City of Tualatin

SUBDIVISION REVIEW FINDINGS AND DECISION FOR SB 13-02, MISSION WOODS

This staff report recommends approval of an 8-lot plan for the Mission Woods Subdivision, as shown on plans dated May 16, 2013 attached as Exhibit B, with conditions of approval as outlined in the staff report.

MISSION WOODS
 TUALATIN, OR
 UTILITY PLAN

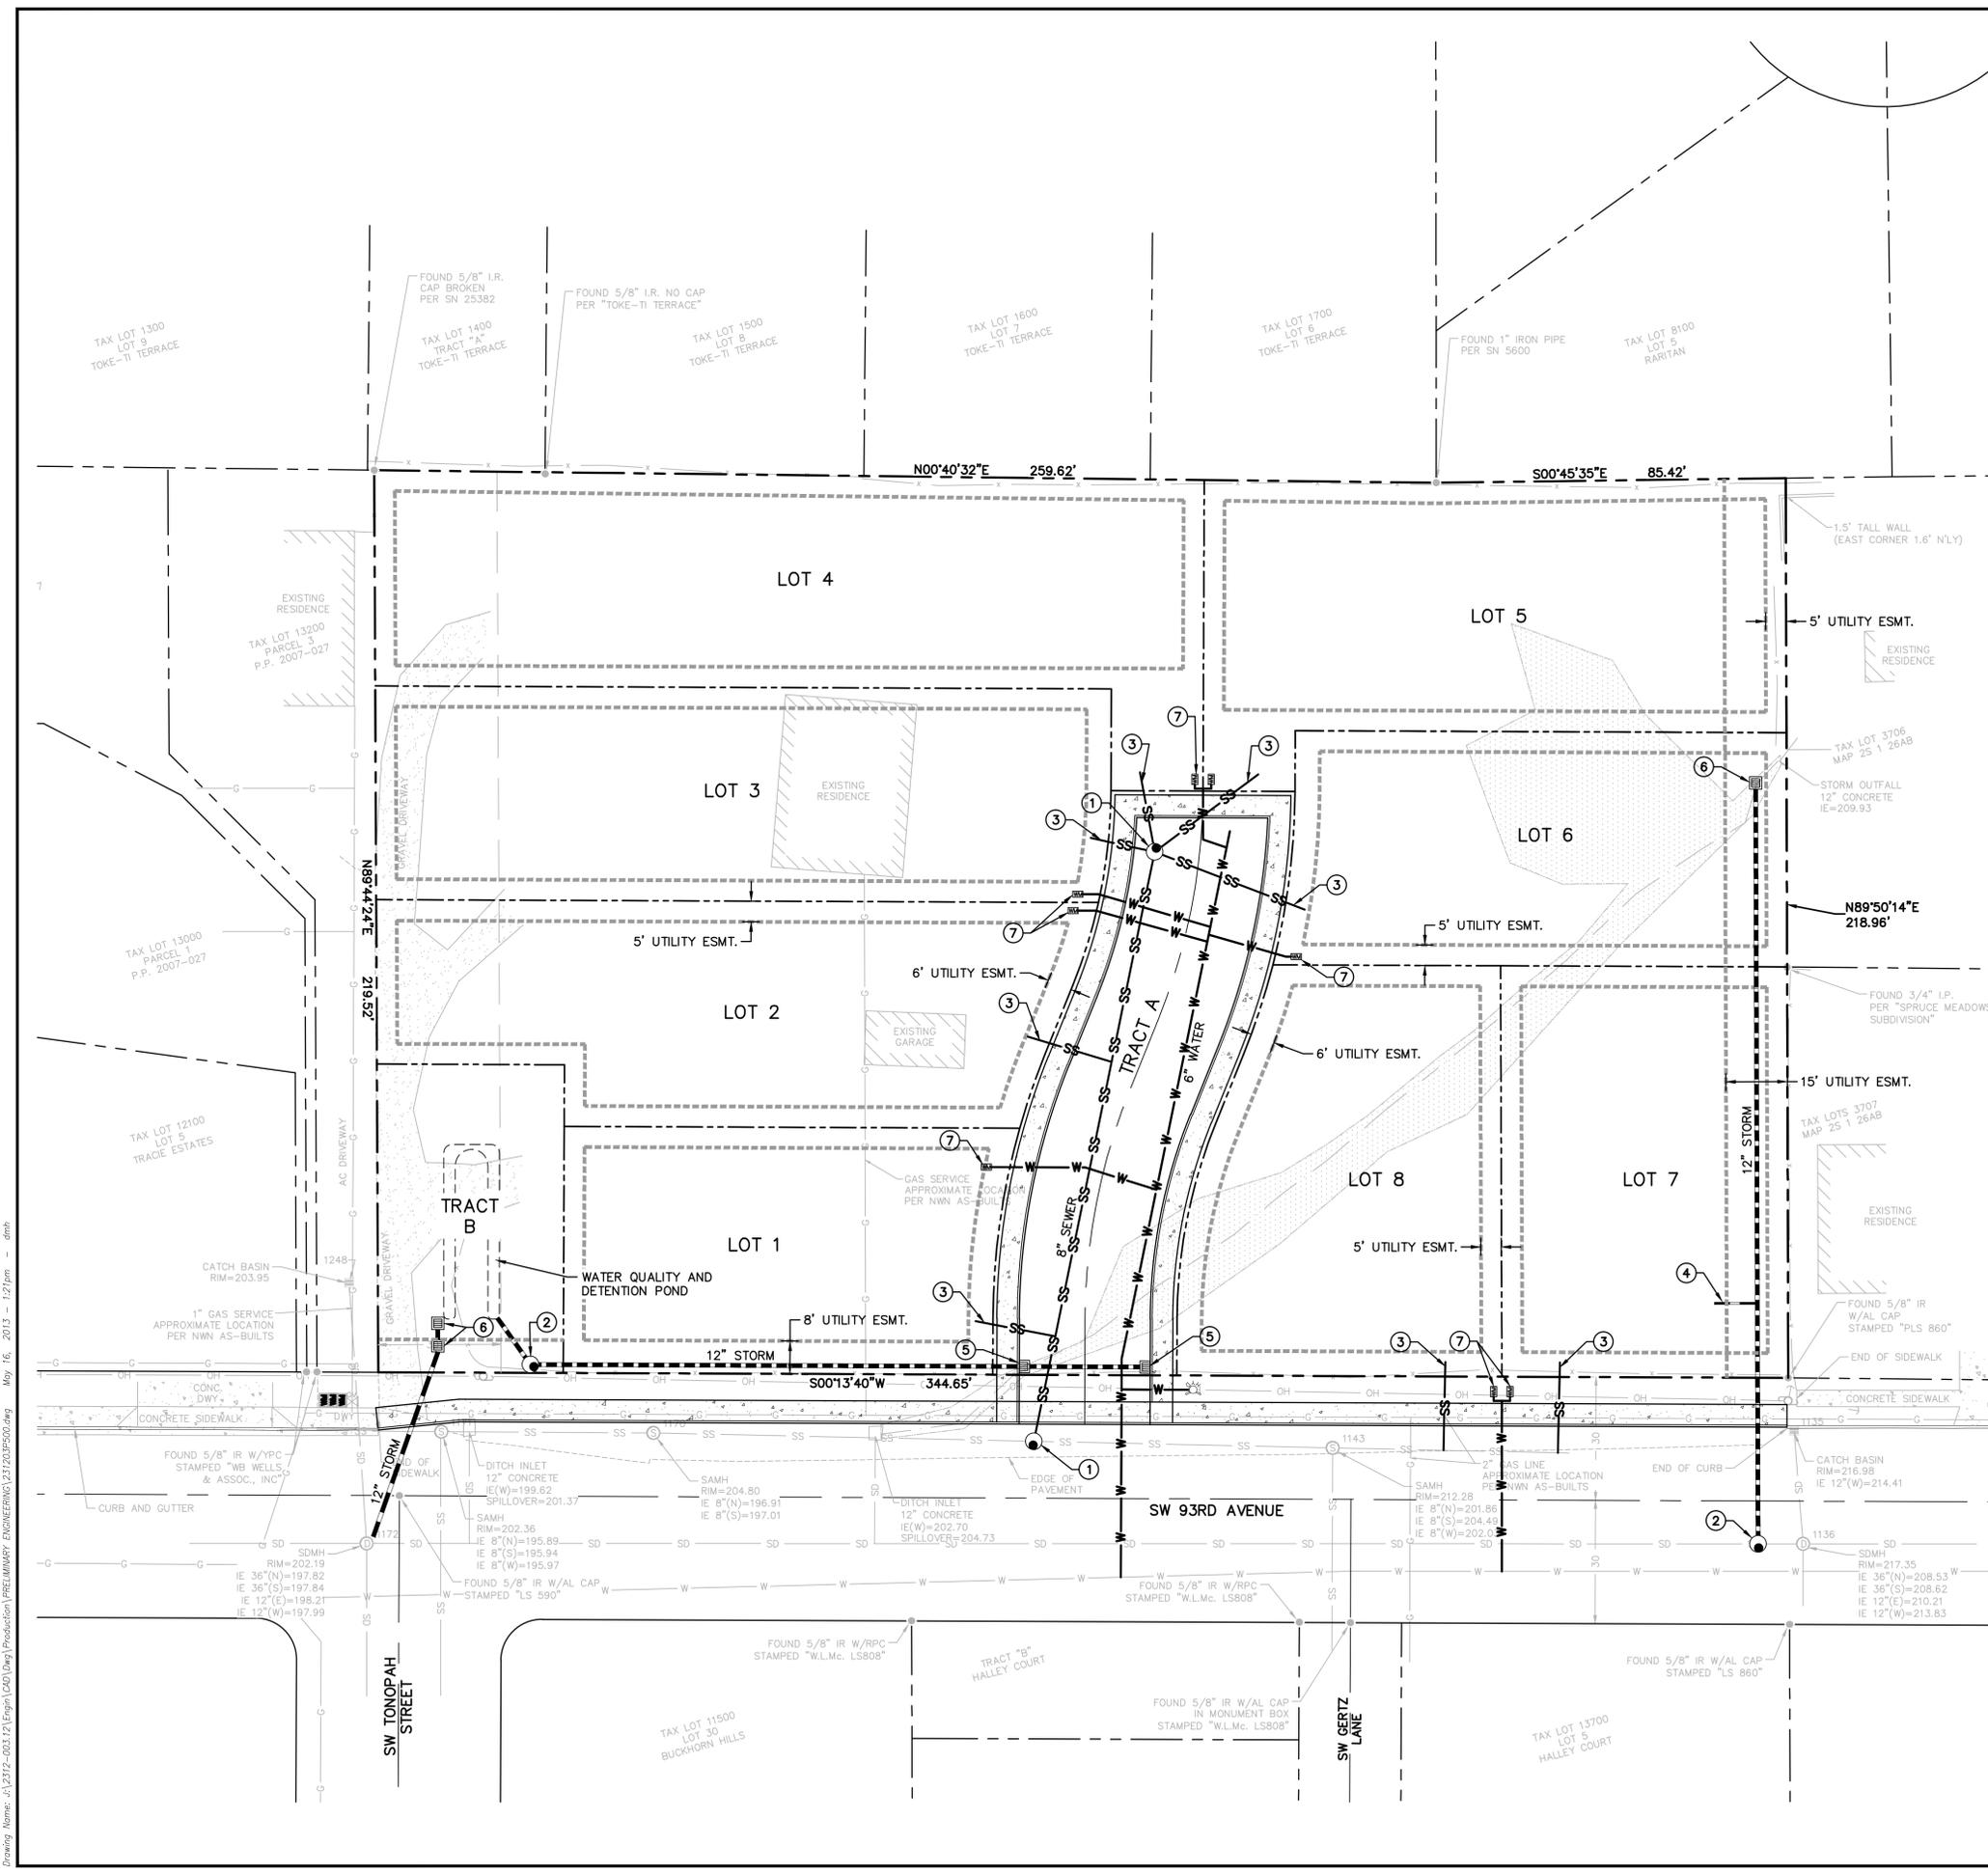
A public water line exists within SW 93rd Avenue. The submitted plans show a new 6-inch public water line from SW 93rd Avenue to extend east within the proposed the private tract. This new line would provide service for lots 1 through 6. Proposed laterals for lots 7 and 8 are shown to connect to the existing line in SW 93rd Avenue.

The configuration for lots 1 through 6 places water meters at the end of each lateral along the private tract. Water meters should be adjacent to public right-of-way, which will eliminate the need for a public water line extension within the private tract. The applicant will need to submit revised water plans that include laterals for lots 1 through 6 adjacent to SW 93rd Avenue with private laterals in the private tract within a private water easement, for review and approval.

There is no water service for the public water quality facility. Water service is needed to establish plants within facilities. The applicant will need to submit revised water plans that show water service for the public water quality facility, for review and approval.

A public sanitary sewer line exists within SW 93rd Avenue. The submitted plans show a new manhole in SW 93rd Avenue to extend an 8-inch public line east within the proposed private tract. This new line would provide service for lots 1 through 6. Proposed laterals for lots 7 and 8 are shown to connect to the existing line in SW 93rd Avenue. This is acceptable. The applicant will need to submit final sanitary sewer plans, for review and approval.

City vehicles need to access sanitary sewer manholes for maintenance. A 12-foot wide surface to support a 50,000 pound vehicle is needed to manholes within an access easement. The applicant will need to submit plans that show surfaces from public right-of-way to onsite sanitary sewer manholes to support City maintenance vehicles, for review and approval. The applicant will need to submit access easements to sanitary sewer manholes, for review and approval.

The plans show an existing 12-inch public stormwater line from the south outfalling into the wetlands on this site. A proposed catch basin would capture this stormwater and convey it west through a 12-inch public stormwater line in a 15-foot public stormwater easement to an existing public stormwater line in SW 93rd Avenue. Lot 7 has a lateral connecting to this proposed 12-inch public line. Two catch basins at the west end of the private tract would capture stormwater from the tract and lots 1 through 6 & 8 via a shared stormwater easement. This stormwater would be conveyed along the west side of lot 1 within a 12-inch public stormwater line in an 8-foot public stormwater easement. The stormwater would outfall into a proposed public tract with a stormwater treatment and detention facility at the northwest corner of the site. The facility would release to a 12-inch public stormwater line connecting to an existing manhole in SW 93rd Avenue.

The applicant has stated the need to extend the 12-inch public stormwater line east within the proposed private tract to adequately serve the adjacent lots. This is acceptable. The applicant will need to submit revised stormwater plans that show the proposed 12-inch stormwater line within the private tract, for review and approval.

City vehicles need to access stormwater manholes and the public stormwater facility for maintenance. The plans do not show vehicular access to the public water quality facility. A 12-foot surface capable of supporting a 50,000 pound vehicle is needed to the water quality manhole and catch basins. The applicant will need to submit revised plans that show a 12-foot surface capable of supporting a 50,000 pound vehicle from SW 93rd Avenue to the public stormwater facility, for review and approval.

In order to maintain the proposed catch basin at the existing outfall a 15-foot access easement and 12-foot surface with turn-around capable of supporting a 50,000 pound vehicle would be needed. The requested option is a continuously piped connection with a manhole at the turn by the outfall can be maintained from the proposed manhole in SW 93rd Avenue. The applicant will need to submit revised stormwater plans that show the outfall and proposed pipe connected via manhole, for review and approval.

The plans show a 15-foot wide public stormwater easement for the proposed public stormwater line along the south side of the development. This is acceptable. The proposed public line adjacent to SW 93rd Avenue is shown in an 8-foot public stormwater easement over lot 1 and without an easement on the private shared access tract. This line is approximately 8-feet from the back of the curb-tight sidewalk. Behind the curb-tight sidewalk is a 4-foot planter strip with street trees in the center. The line needs to be at least 7.5 feet past the street trees, therefore 10 feet from the back of the sidewalk. The applicant will need to submit revised plans that show the public stormwater line adjacent to SW 93rd Avenue 10 feet east of the back of the sidewalk, for review and approval.

- PFR-7 The applicant shall submit revised water plans that include laterals for lots 1 through 6 adjacent to SW 93rd Avenue with private laterals in the private tract within a private water easement, for review and approval.

- PFR-8 The applicant shall submit revised water plans that show water service for the public water quality facility, for review and approval.
- PFR-9 The applicant shall install double check valve assemblies to meet the requirements of TMC 3-3.120(4), for review and approval.

- PFR-10 The applicant shall submit final sanitary sewer plans that show surfaces from public right-of-way to onsite sanitary sewer manholes to support City maintenance vehicles, for review and approval.

- PFR-11 The applicant shall submit revised plans that show a 12-foot surface capable of supporting a 50,000 pound vehicle from SW 93rd Avenue to the public stormwater facility, for review and approval.

- PFR-12 The applicant shall submit revised stormwater plans that show the outfall and proposed pipe connected via manhole and the proposed 12-inch stormwater line within the private tract, for review and approval.

- PFR-13 The applicant shall submit revised plans that show the public stormwater line adjacent to SW 93rd Avenue 10 feet east of the back of the sidewalk, for review and approval.
